Re: Proposed Deacon Hayes Commons, Parsonage/Walnut Hill Roads

We have attached updated plans and provided additional information as requested by the Planning Board during the June meeting. Changes with this submission include:

SUBDIVISION PLAN
 DEACON HAYES COMMONS
 527 WALNUT HILL ROAD - NORTH YARMOUTH MAINE
 OWNER OF RECORD
527 LLC
 265 OAK HILL ROAD - NORTH YARMOUTH, ME

SHEET SUB-1

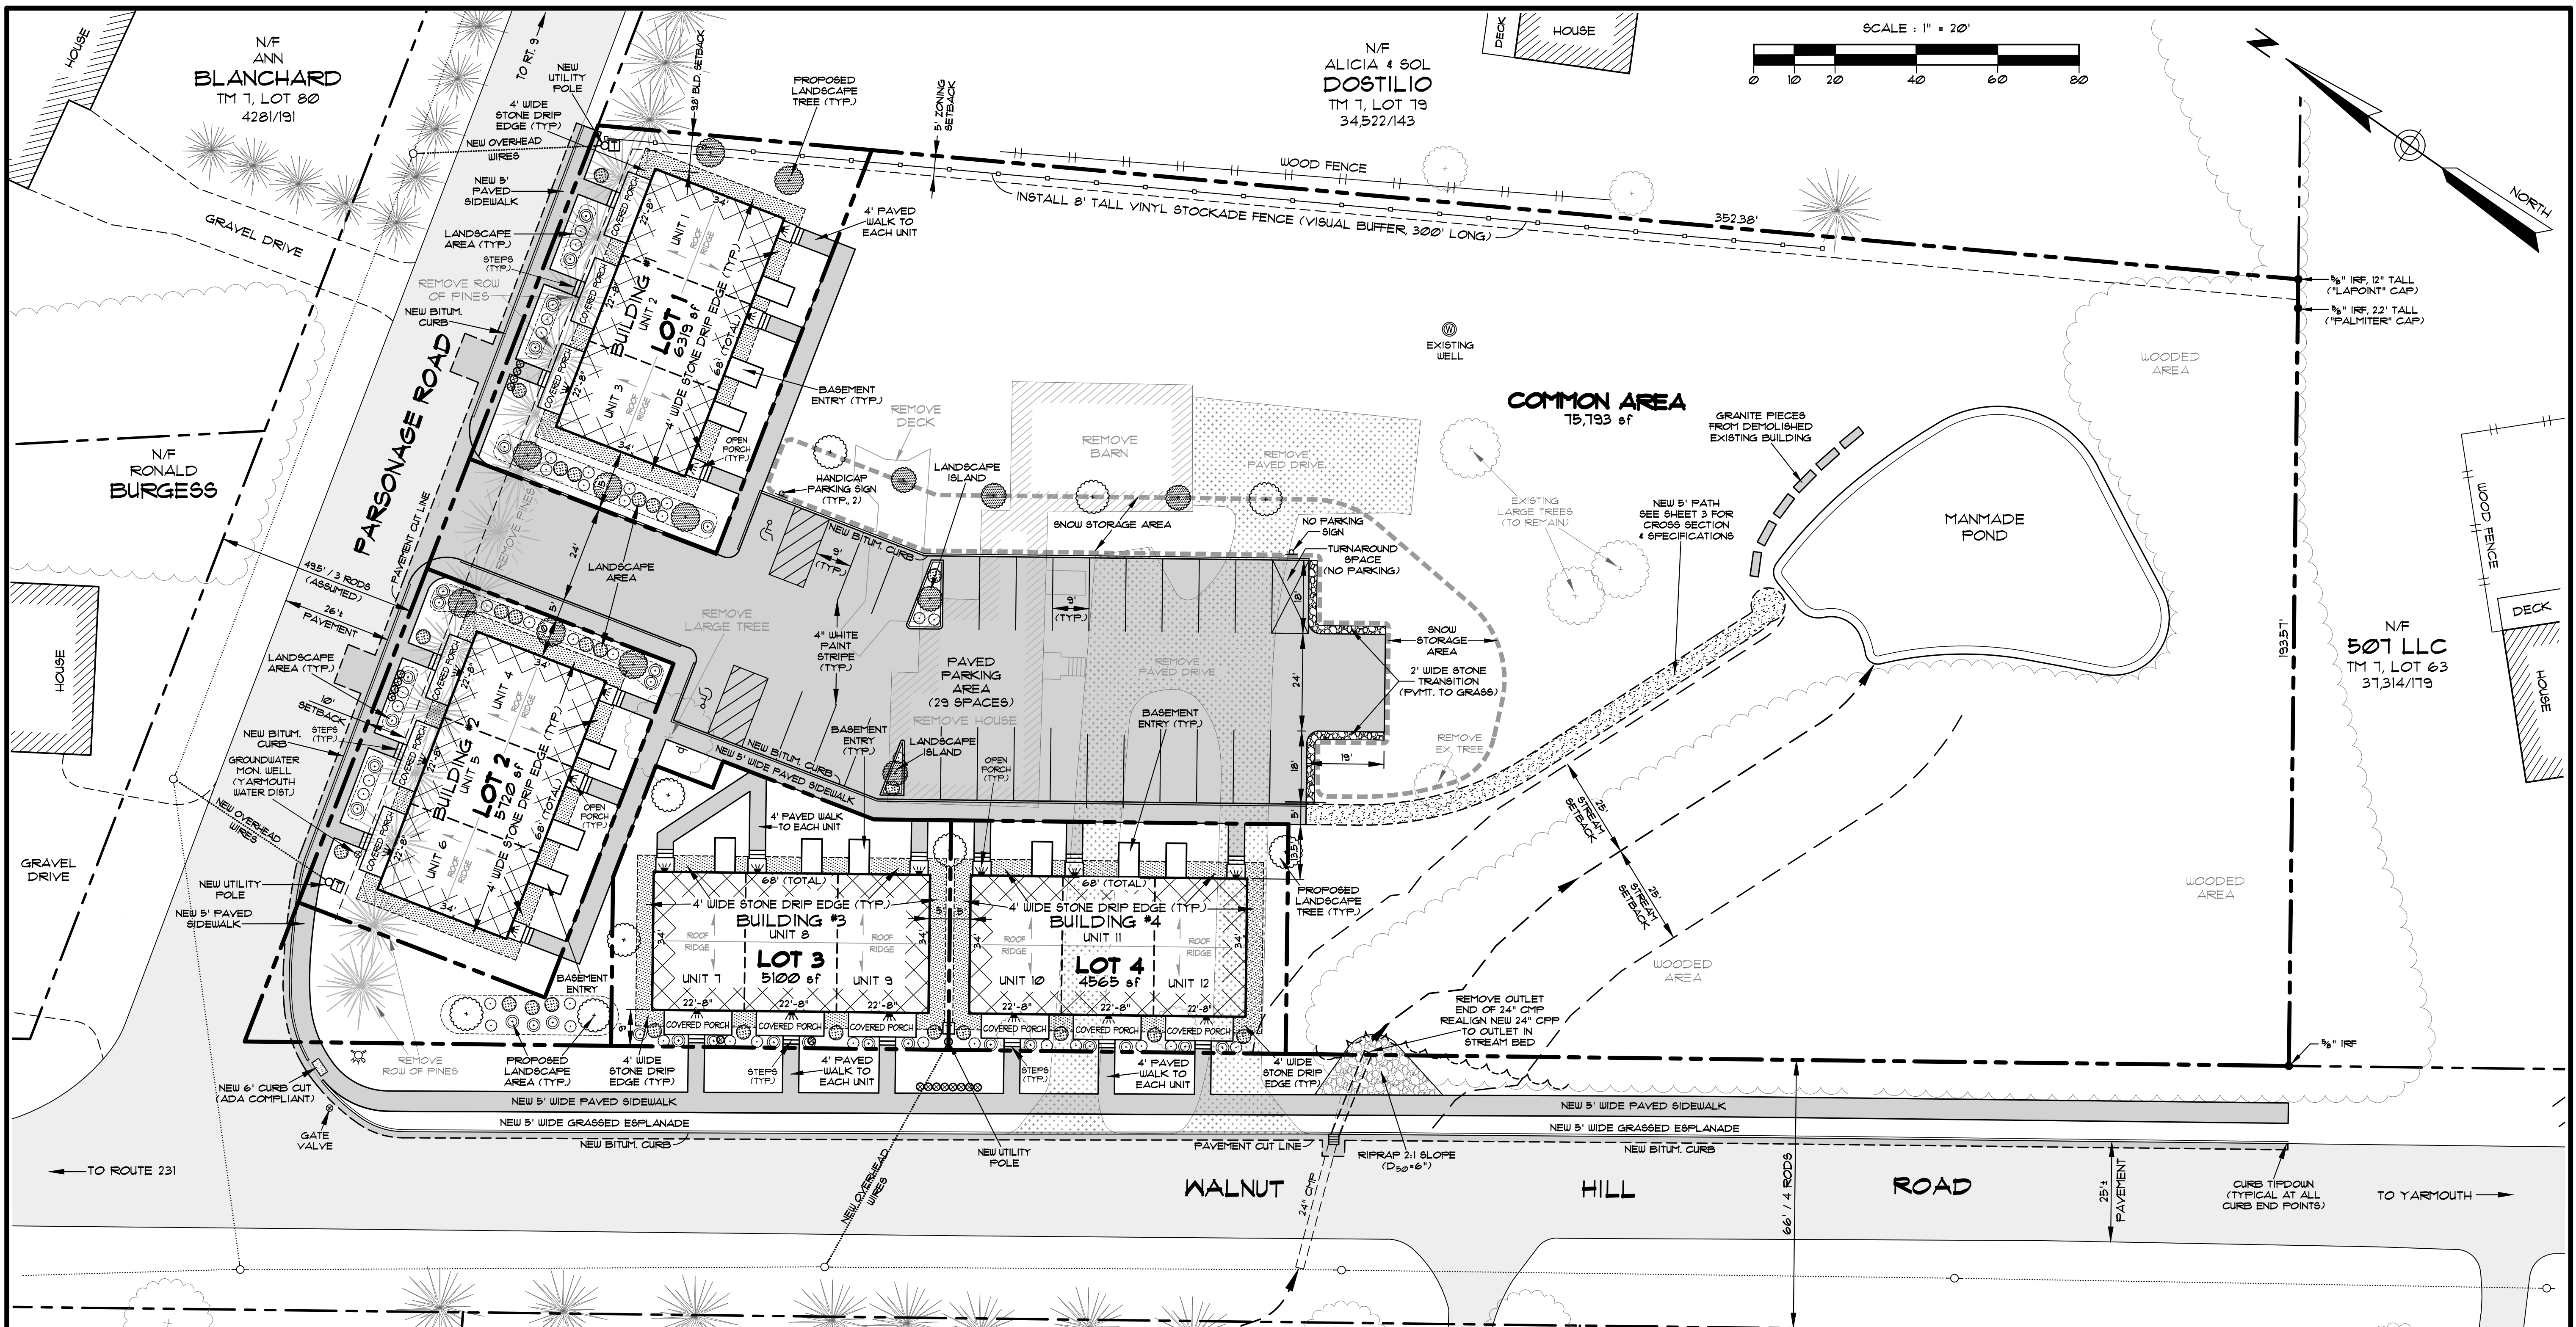
1. Additions of property lot lines for Lots 1 thru 4 including a common area.
2. Addition of a subdivision plan suitable for Planning Board signatures and recording in the registry.

SITE & DEMOLITION PLAN
 DEACON HAYES COMMONS
 521 WALNUT HILL ROAD - NORTH YARMOUTH MAINE
 PREPARED FOR
527 LLC
 865 OAK HILL ROAD - NORTH YARMOUTH, ME

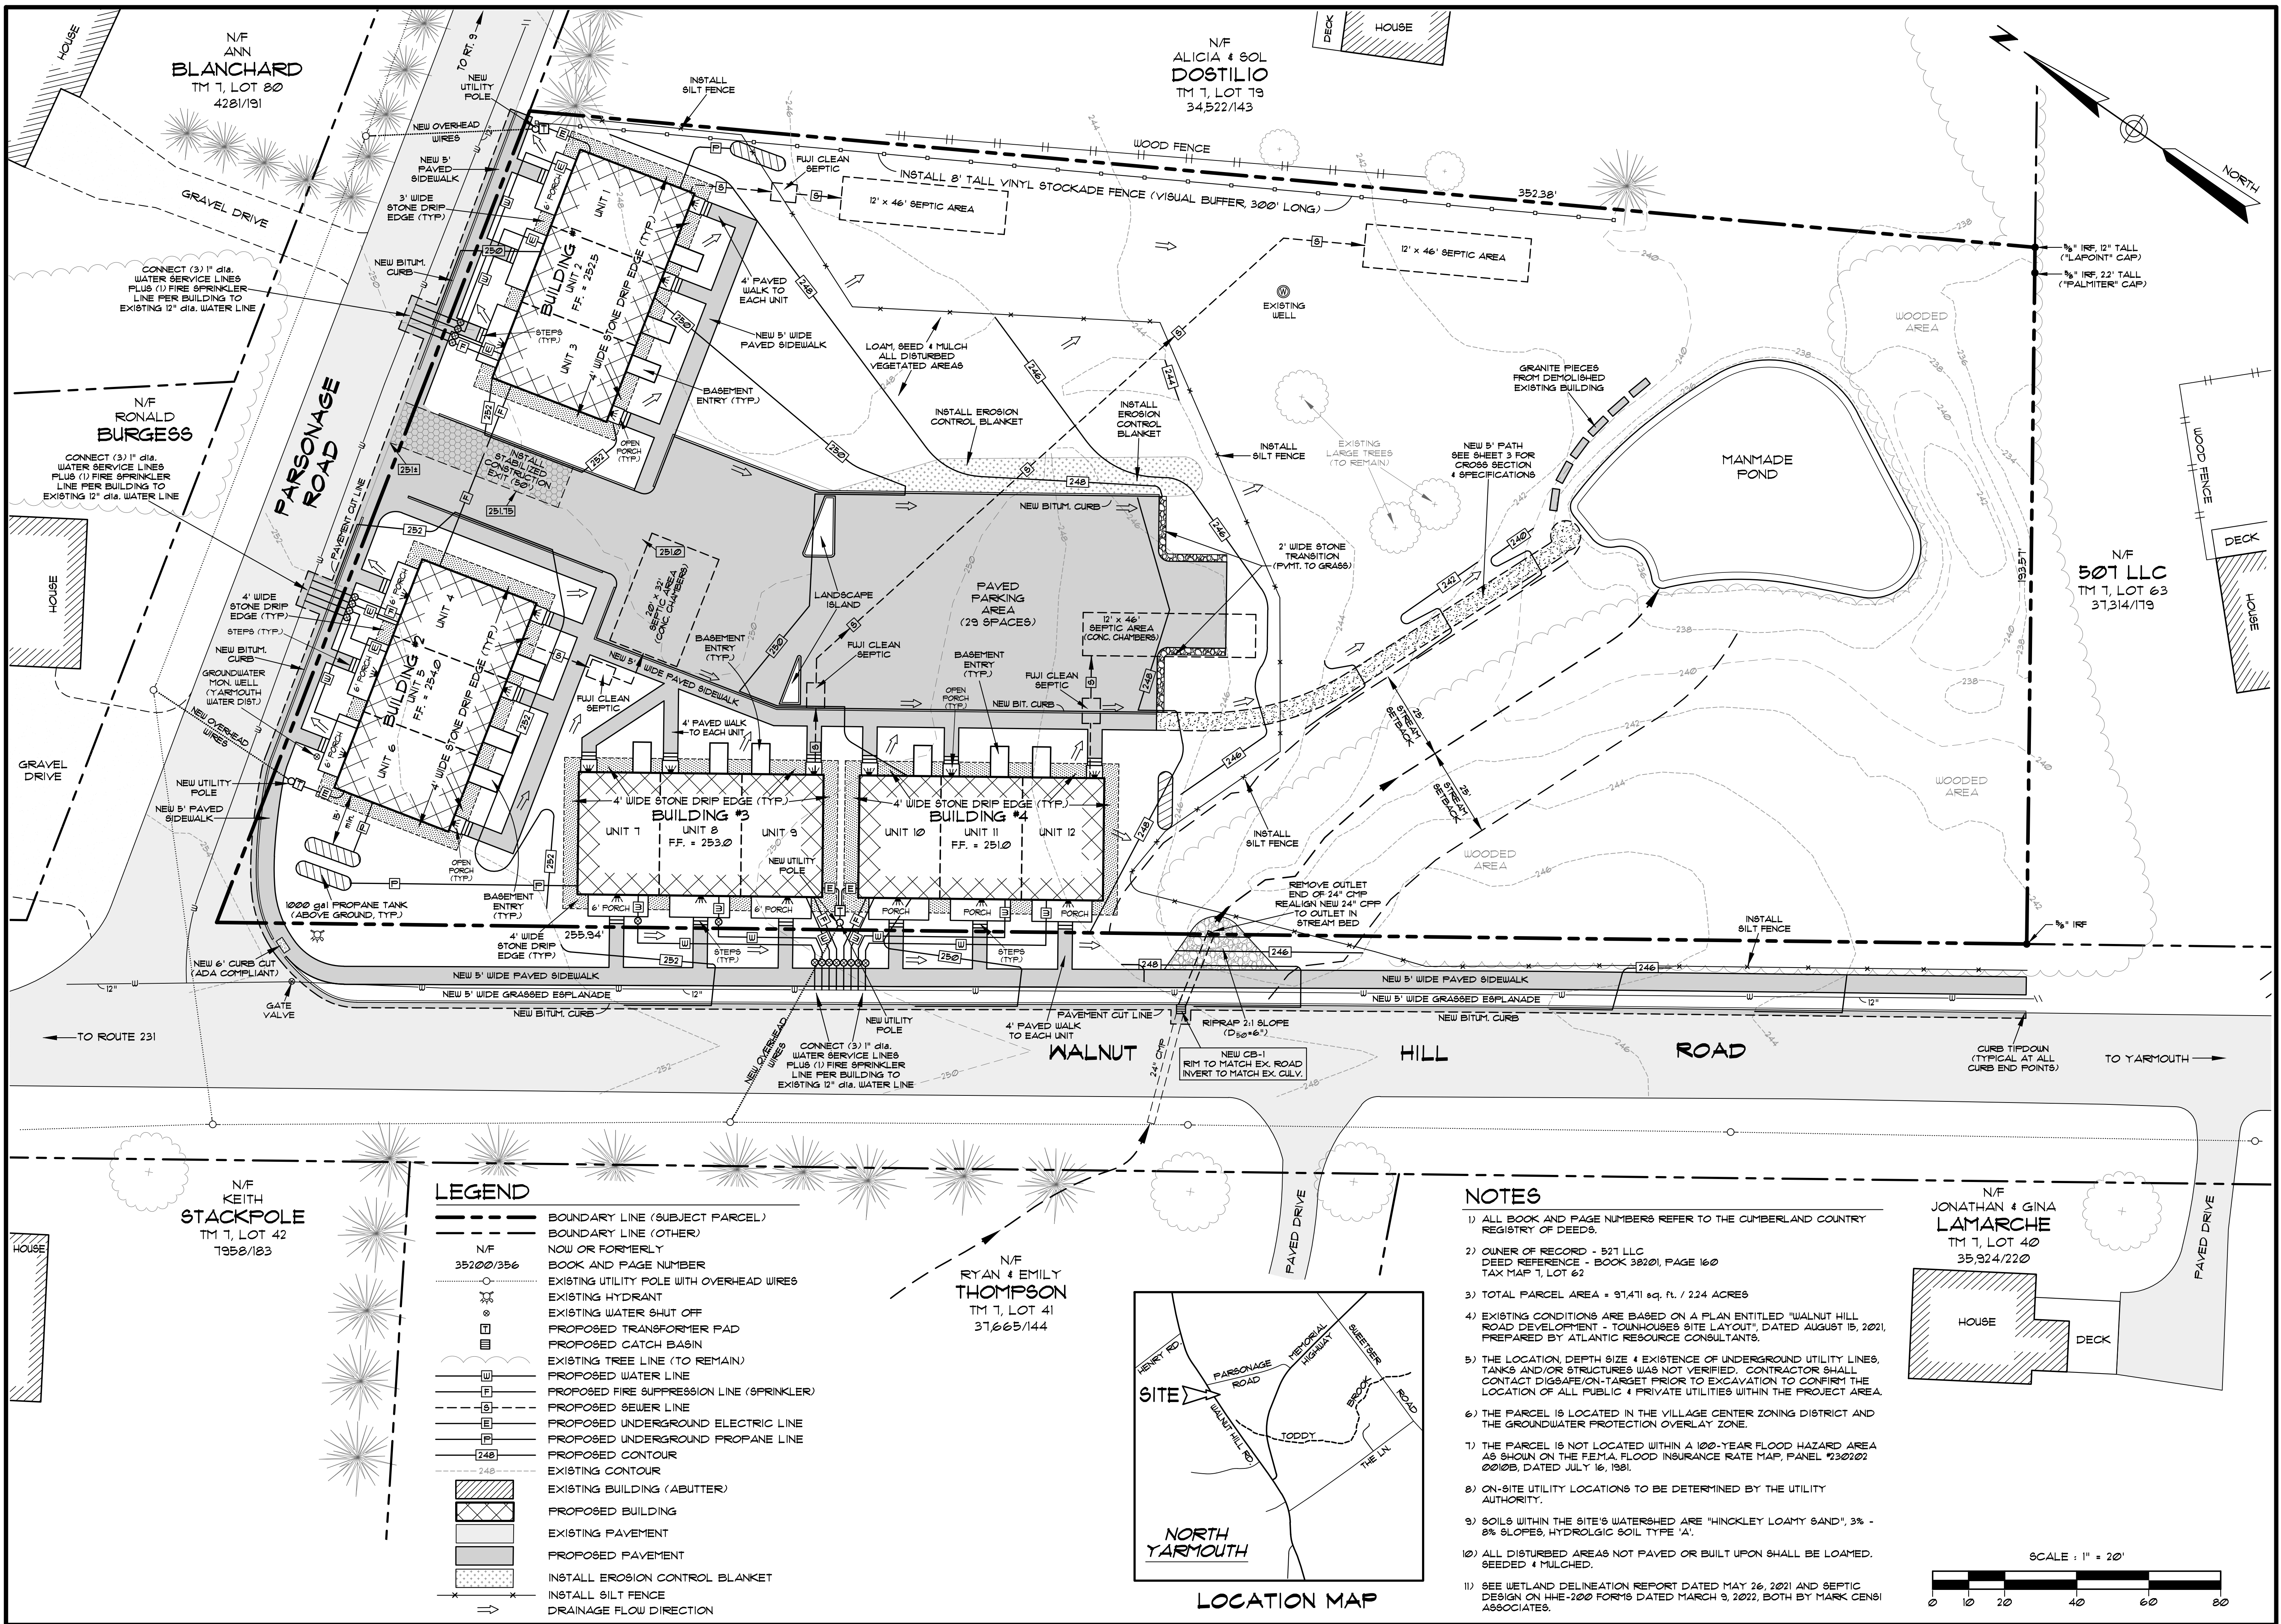
3. Building unit numbers have been added.
4. Units 8 and 11 are designated to be "Affordable Housing".
5. Updated water service lines going to each building. The domestic water lines are to be 1" diameter. The fire suppression line size (4" or 6") will be determined at a later date prior to building permit application.

6. The existing 12" water main has been added to the plan along both Walnut Hill and Parsonage Roads.
7. Updated section concerning septic tank testing.

8. Fire Chief comments letter.
9. Existing Walnut Hill and Parsonage Road widths added to plans.
10. Drainage arrows added to plan.
11. Extension of the proposed sidewalk to the property corner along Walnut Hill Road has been added.

12. Snow storage area added to the plans.
13. Relocated and added additional parking lot trees.
14. Added propane tanks for each building to the plans.
15. We had added additional material pertaining to Maintenance Items pertaining to the Municipality, an estimated net increase in taxable assessed valuation, Performance Guarantee estimate, additional language to the HOA, and cost of development.
